SERVICE BULLETIN

APPLICABILITY: 2013-14MY BRZ

NUMBER: 12-162-14

SUBJECT: Design Change to Rear Combination Lamps to Prevent Insect Intrusion

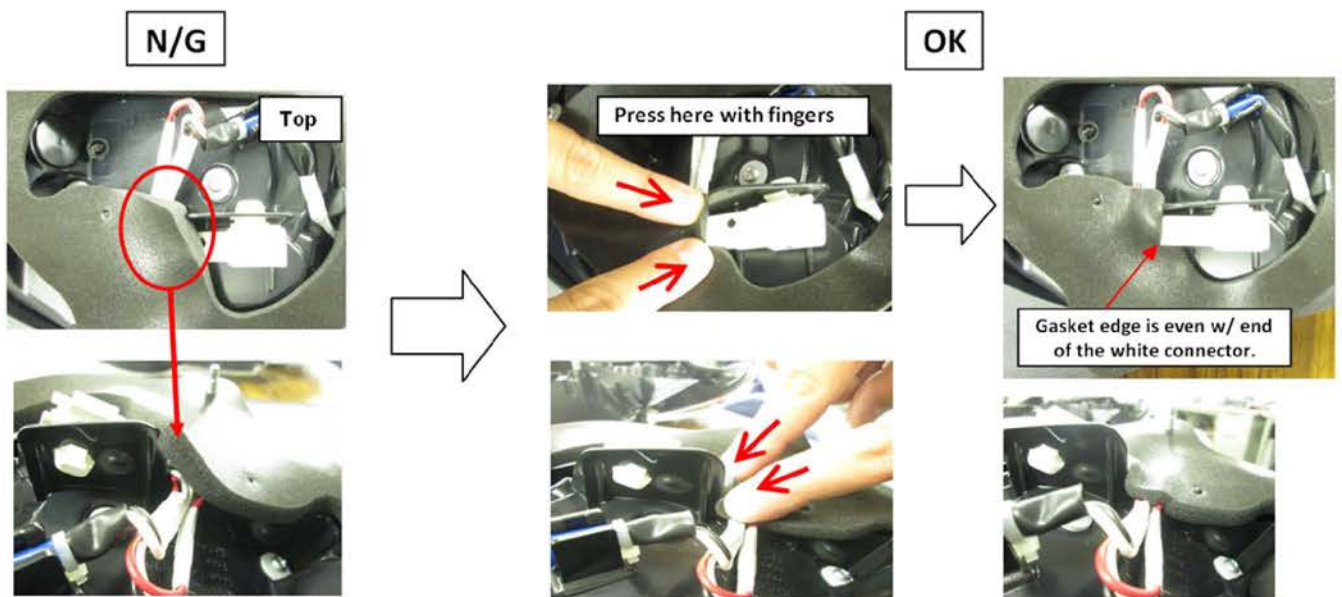
A design change has been made to the rear combination lamp assemblies and the packing (gaskets) to prevent insects from getting inside the housings. Extra ribbing has been added around the vehicle harness connector openings along with a revised shape and addition of double-sided tape to the gaskets for improved sealing.

The revised combination lamps and gaskets were incorporated into production starting with the following VIN: **E*601089**.

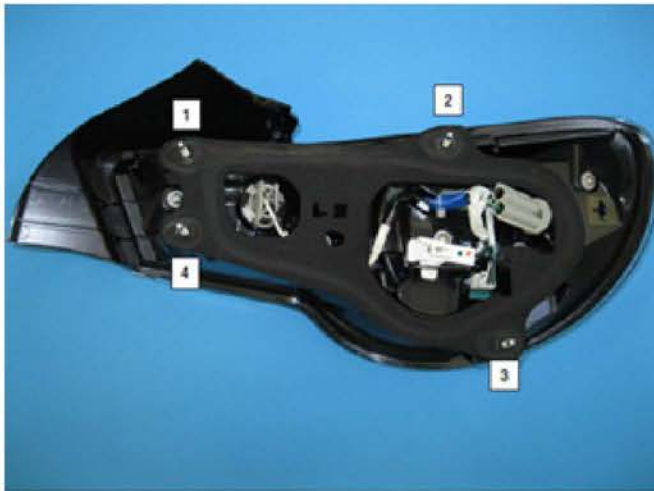
- Peel the tape backing of the new gaskets to expose the adhesive then install the gasket down over the mounting studs. Position the revised shape area and adhesive of the gasket over the additional ribbing and align the edge with the white harness connector as shown in the photos below (right side lamp shown).

- Refit the combination lamp assemblies to the vehicle but before tightening the retaining nuts, confirm the new gaskets are in the proper position as shown in the photo below (left side shown).

L/H Sequence

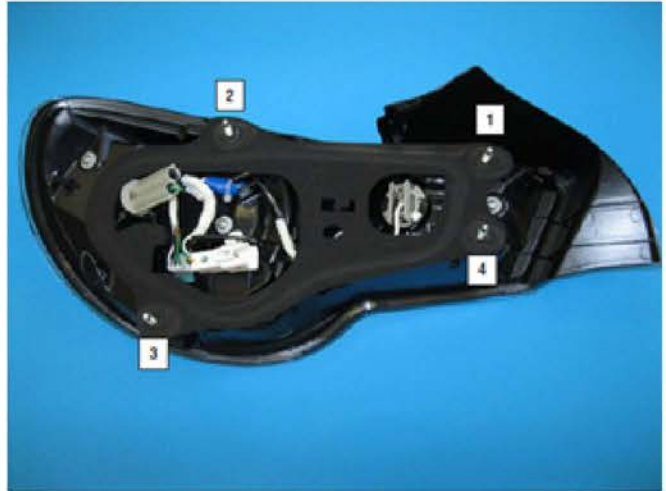
- The proper torque sequence must be followed as shown in the following illustrations or damage to the combination lamp assembly may result. The torque specification for the retaining nuts is 4.5 Nm (39 inch-pounds).
